September 15, 2009

Subject: UniStar Nuclear Energy, NRC Docket No. 52-016  
Response to Request for Additional Information for the  
Calvert Cliffs Nuclear Power Plant, Unit 3  
RAI No. 58, Seismic Design Parameters, Questions 03.07.01-1 and 03.07.01-10  
RAI No. 65, Seismic System Analysis, Questions 03.07.02-18 and 03.07.02-24  
RAI No. 112, Seismic Design Parameters; Question 03.07.01-11

**Response to NRC Request for Additional Information,  
RAI No. 58, Seismic Design Parameters, Questions 03.07.01-1 and 03.07.01-10,  
RAI No. 65, Seismic System Analysis, Questions 03.07.02-18 and 03.07.02-24, and  
RAI No. 112, Seismic Design Parameters; Question 03.07.01-11  
Calvert Cliffs Nuclear Power Plant, Unit 3**

Figure 3.7-8—{Reactor Bldg Internal Structure, Elev. 5.15 m, X (E-W) Direction, 5% Damping}

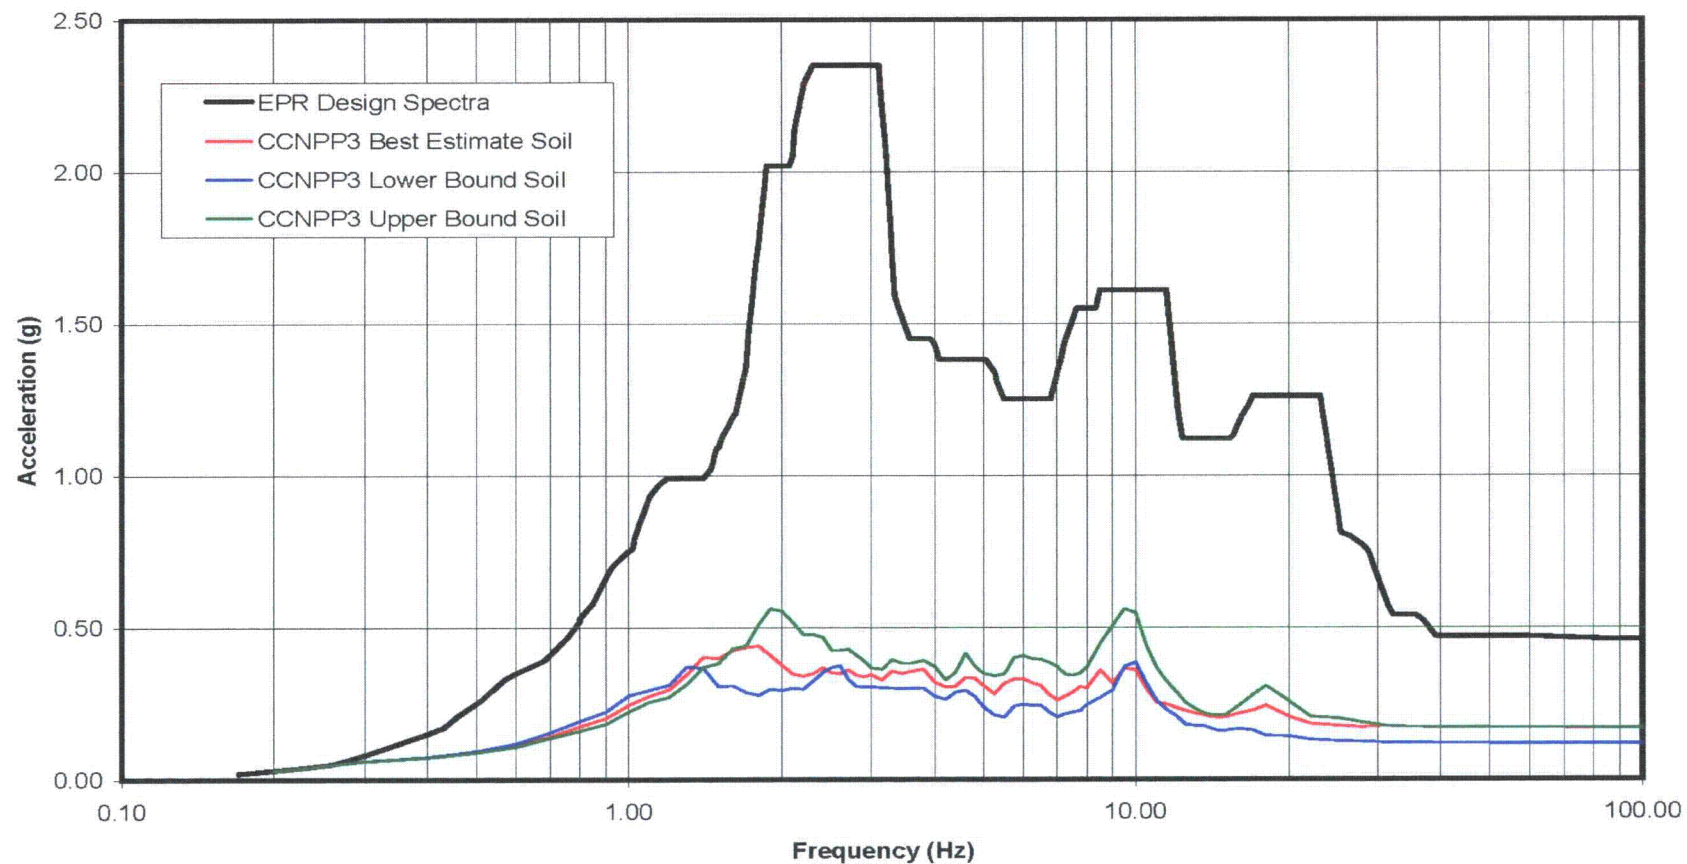
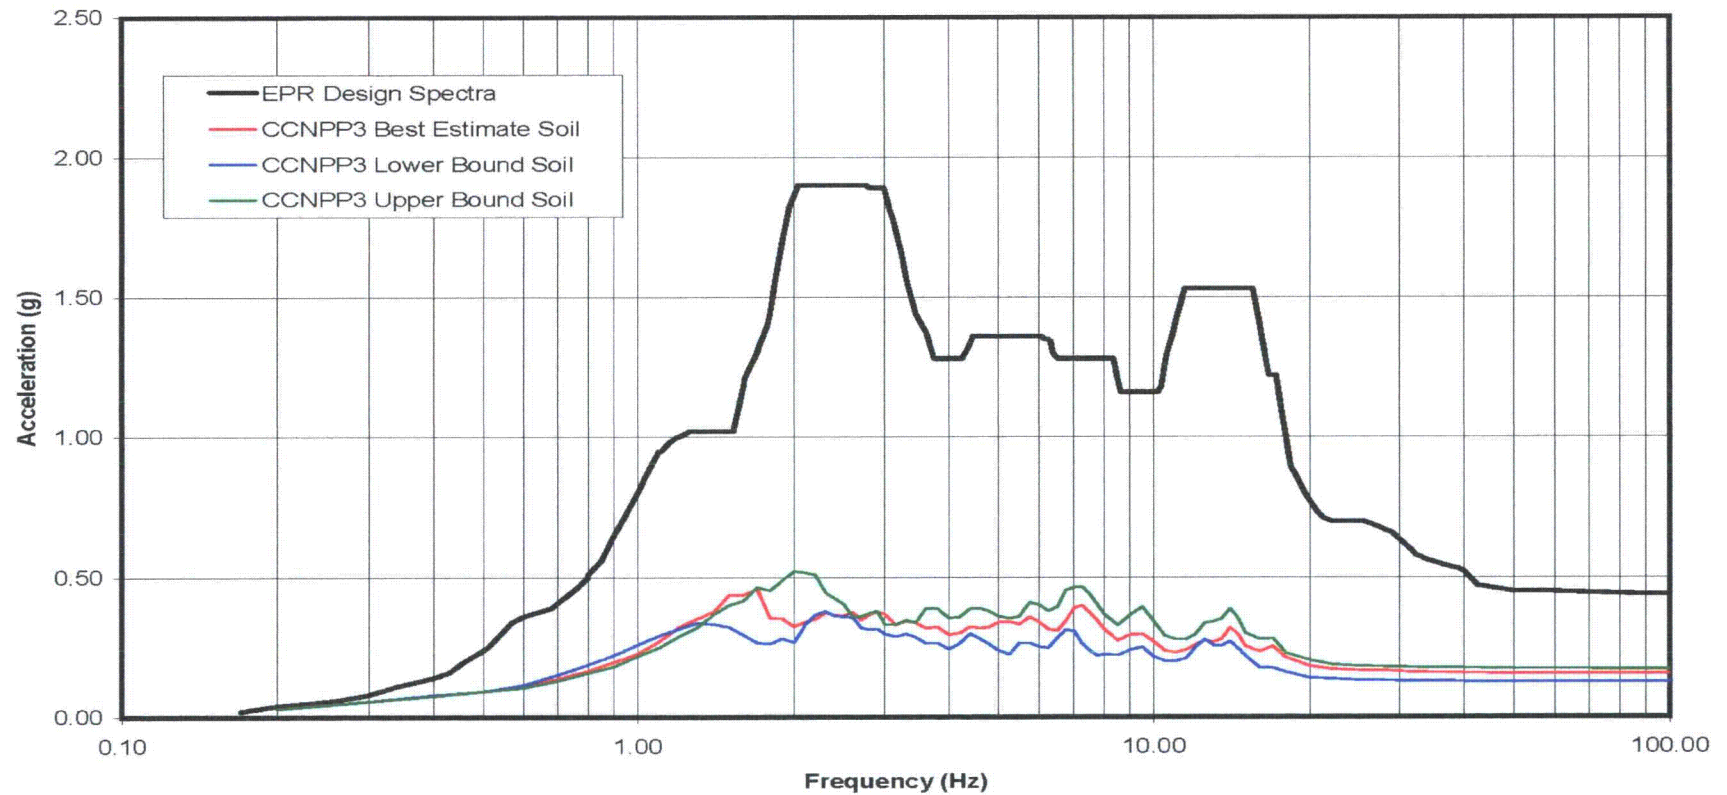
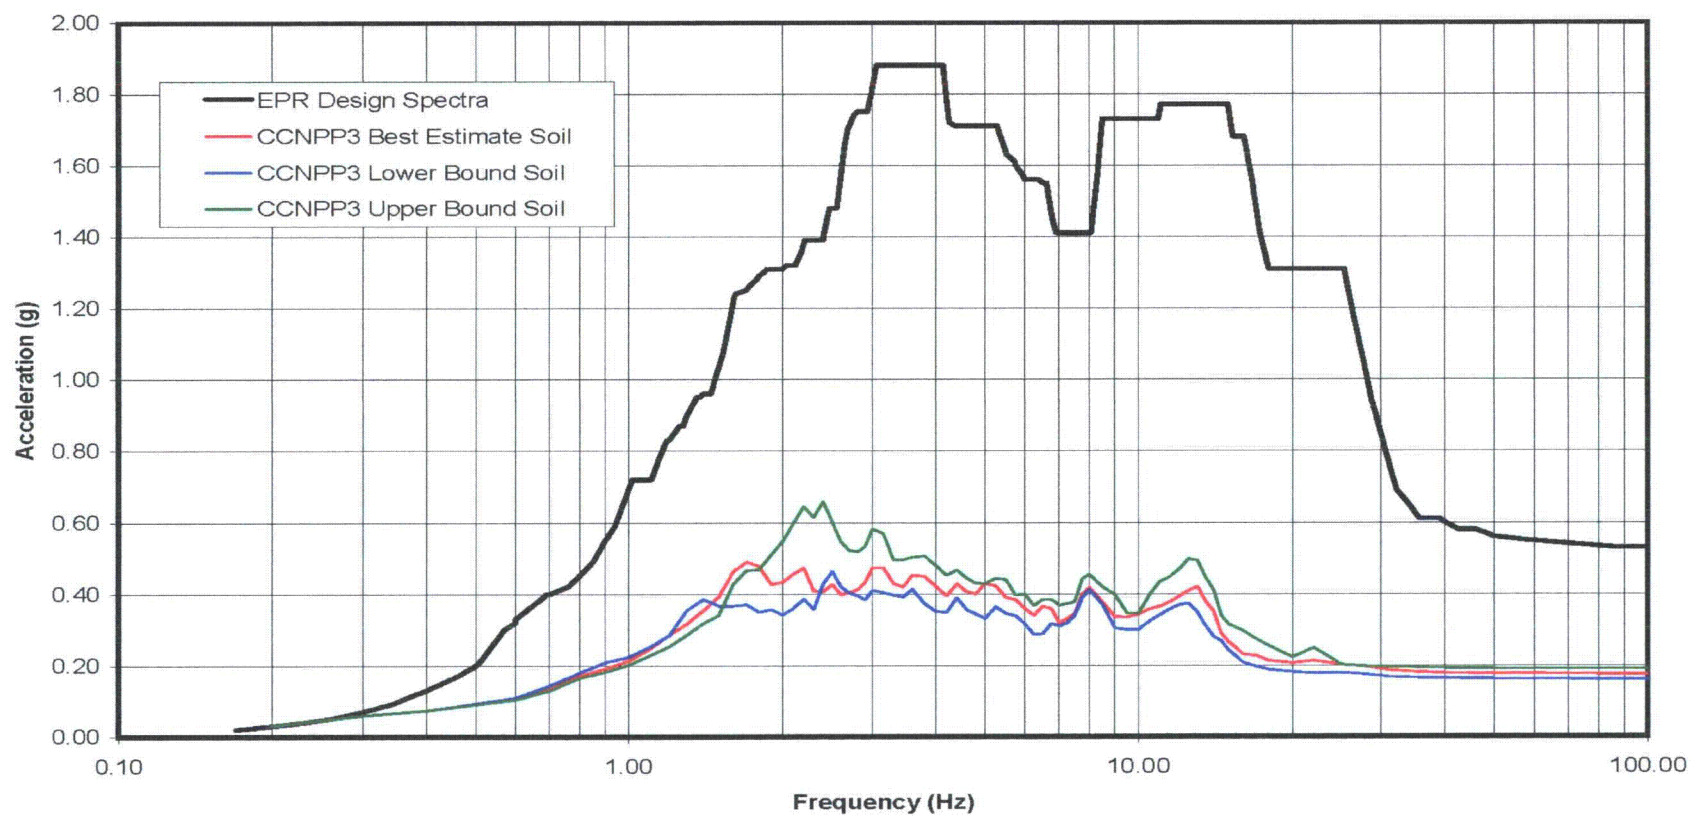
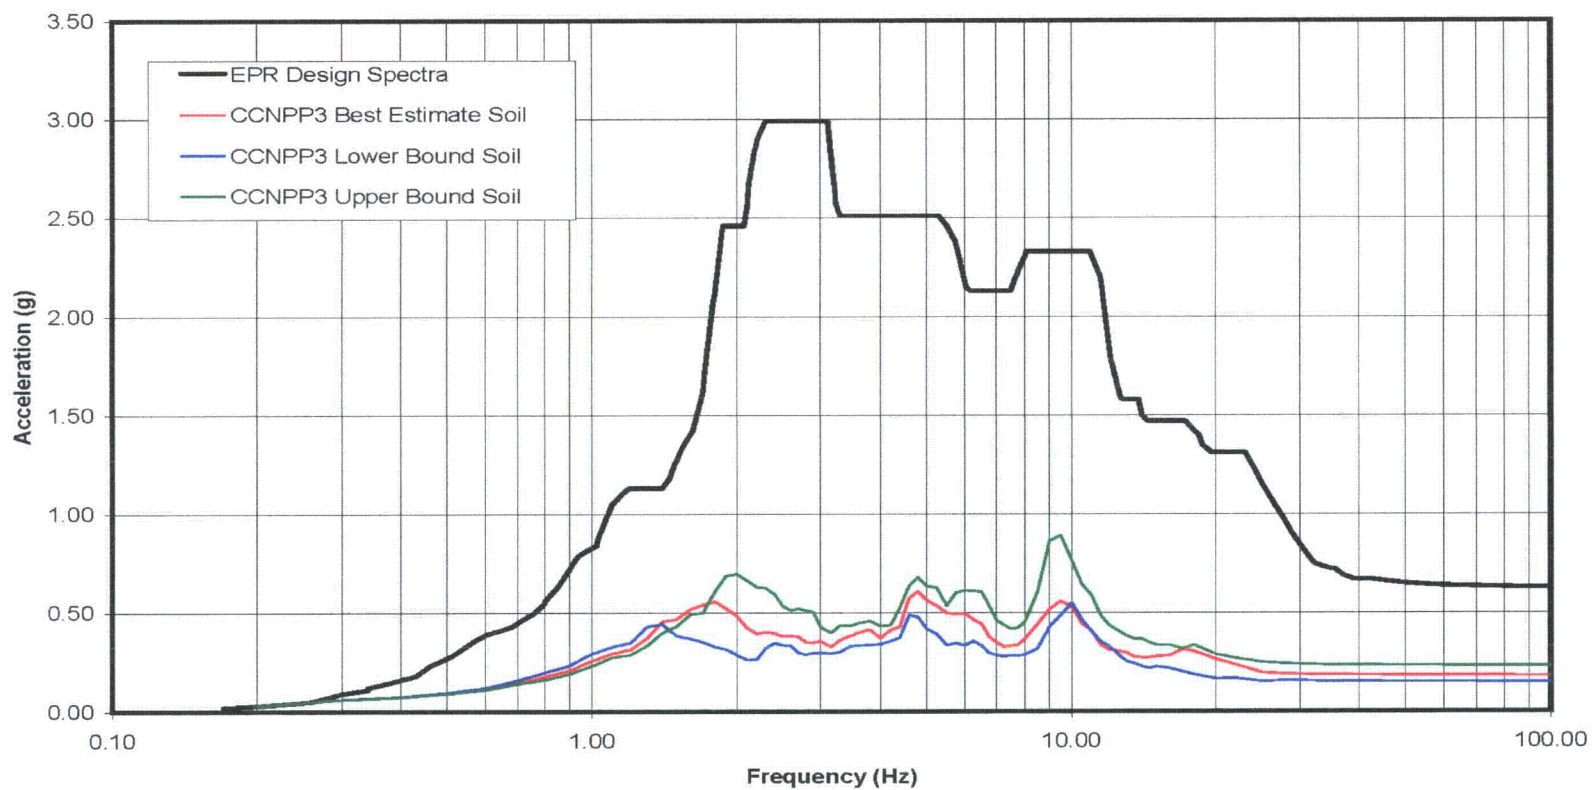
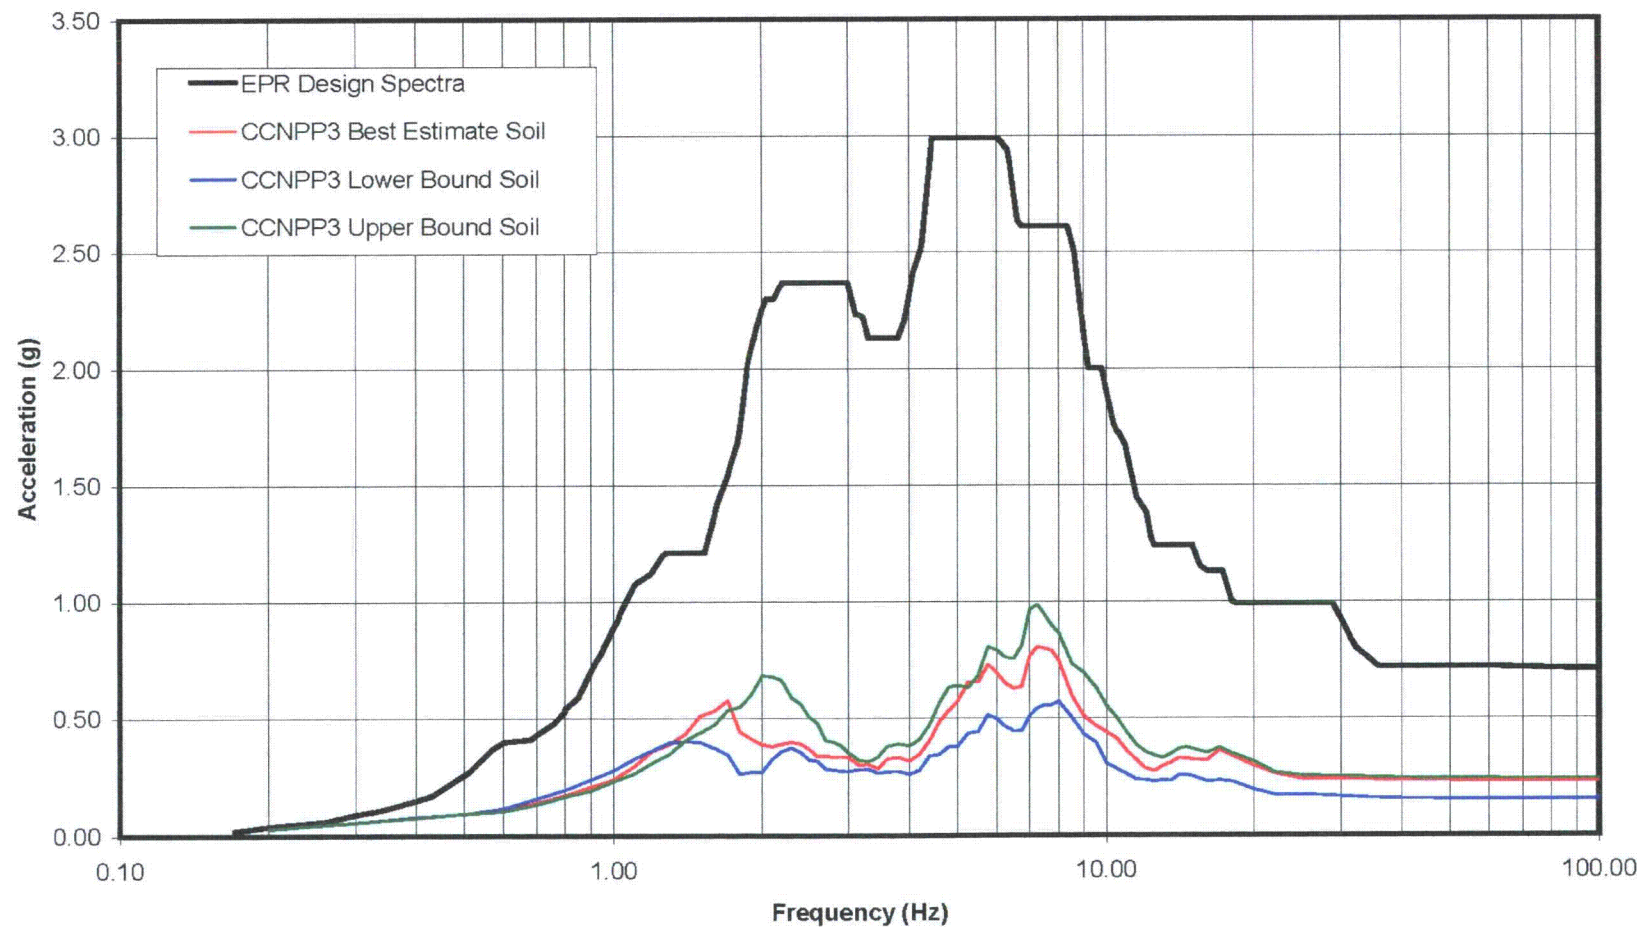
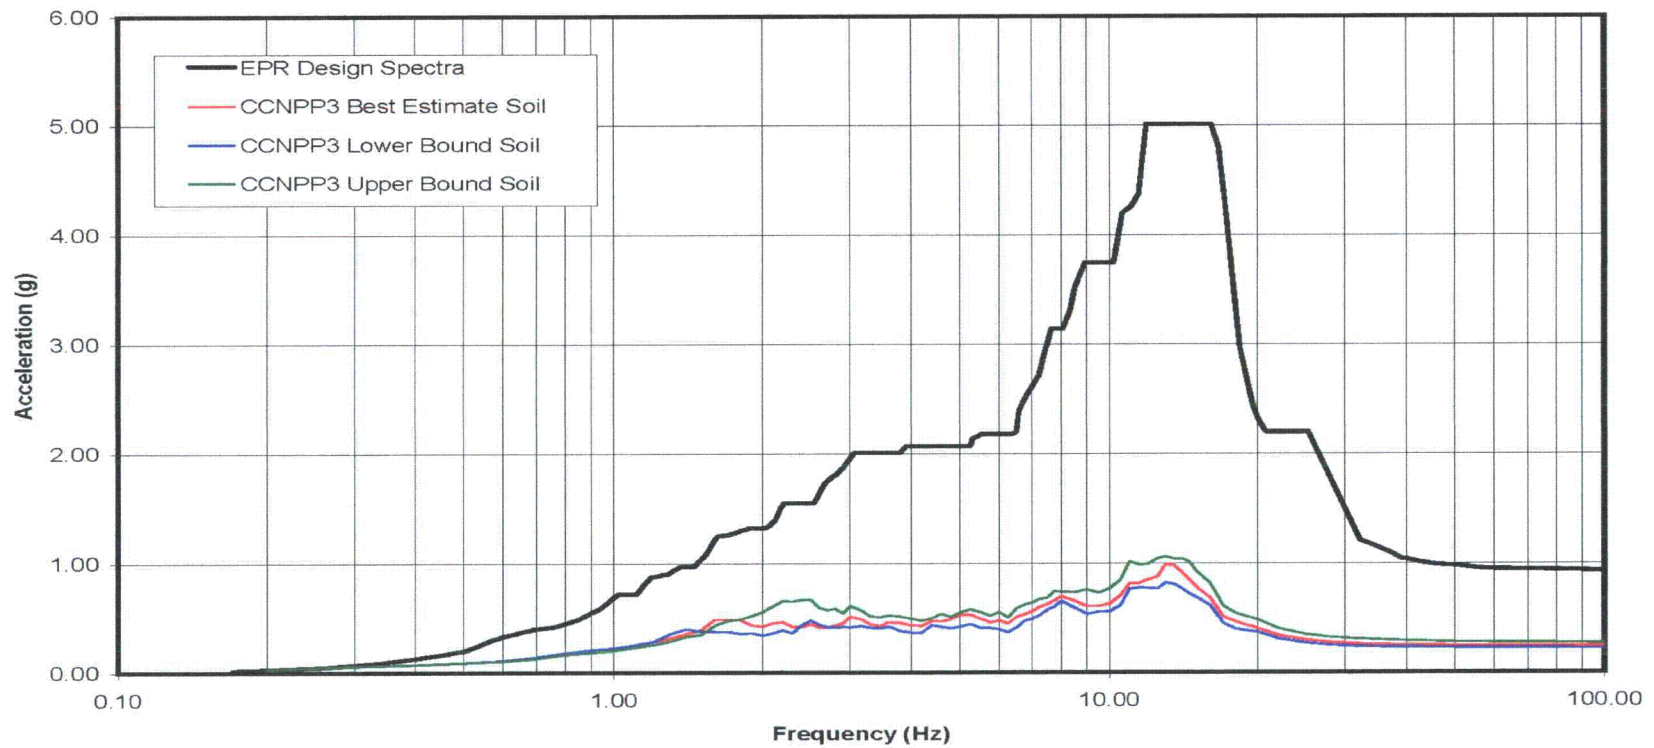
FSAR Section 3.7.1.1.1 (Design Ground Motion Response Spectra), on page 3.0-30, describes the best estimate soil profiles for CCNPP Unit 3. The comparison of the generic site soil columns with the site-specific information shown in FSAR Figure 3.7-7 is based on low-strain best-estimate shear wave velocities. The lower bound shear wave velocities are provided in Table 3.7-2. In this table, layers 4 and 5 have a shear wave velocity of 243.5 m/sec (799 ft/sec), while layers 7 through 25 have a shear wave velocity of 269.4 m/sec (883.9 ft/sec). In both instances, the lower bound shear wave velocity is less than 1000 ft/sec the minimum shear wave velocity for the subgrade to be classified as competent material. In addition, the calculated strain dependent properties under seismic load will lower the shear wave velocities from those shown in Table 3.7-2. SRP 3.7.1, SRP Acceptance Criteria 3, states that if the minimum shear wave velocity is less than 1000 ft/sec, additional studies need to be performed addressing potential impact on soil-structure-interaction (SSI), potential settlements and design of foundation elements. Lower subgrade properties may invalidate the assumption that the mat is rigid in the SSI analysis thus affecting the analysis results, as well as the nuclear island (NI) design loads for seismic and accident design conditions. As the assumption of a non-rigid mat may produce additional seismic bending loads into the mat and NI superstructure, what is the technical justification for using a rigid mat in the SSI analysis with the lower bound soil properties? What is the possible impact on the SSI analysis results and on the design of the foundation mat and supported superstructure?

Soil Structure Interaction (SSI) analyses for the Nuclear Island (NI) common basemat structures are revised using site-specific Safe Shutdown Earthquake (SSE) input motion and corresponding strain-compatible soil properties. FSAR Figure 3.7-1 and Figure 3.7-2 are revised to show a comparison of the Certified Seismic Design Response Spectra (CSDRS) with the horizontal and vertical Foundation Input Response Spectra (FIRS), respectively. FSAR Table 3.7-1, Table 3.7-2, and Table 3.7-3 are revised to show the updated Calvert Cliffs Nuclear Power Plant (CCNPP) Unit 3 best estimate, lower bound, and upper bound soil profiles used for SSI analyses, respectively. Accordingly, FSAR Figure 3.7-6 and Figure 3.7-7 are now based on the shear wave velocities for the site-specific strain-compatible soil profiles, instead of site-specific low-strain shear wave velocities. Based on the updated Figure 3.7-7, the range of shear wave velocities of the CCNPP Unit 3 strain-compatible soil profiles are bounded by the generic strain-compatible soil cases used in the U.S. EPR design certification. However, there are variations in the soil layering from the generic soil profiles considered in design certification. In view of such variations, confirmatory site-specific SSI analyses were performed. The resulting In-Structure Response Spectra (ISRS) at representative locations of the NI common basemat structures are bounded by the corresponding design certification ISRS by a large margin. FSAR Figures 3.7-8 through 3.7-34 will be revised to show the updated ISRS comparisons. The margin available for the site-specific responses is deemed more than adequate to cover any potential increases in loads caused by a non-rigid mat. Since the foundation mat and supported superstructure are designed for design-certification-enveloped loads which bound the site-specific loads by a considerable margin, the impact of any potential increases in the loads due to a non-rigid mat would still be bounded by the design loads.

- CCNPP Unit 3 FSAR Section 3.7.1.1.1 will be revised as indicated below.
- CCNPP Unit 3 FSAR Table 3.7-1, Table 3.7-2, and Table 3.7-3 will be replaced with the revised tables.
- CCNPP Unit 3 FSAR Figure 3.7-1, Figure 3.7-2, Figure 3.7-6, Figure 3.7-7 and Figure 3.7-8 through Figure 3.7-34 will be revised as described in the response and indicated on the enclosed markup.
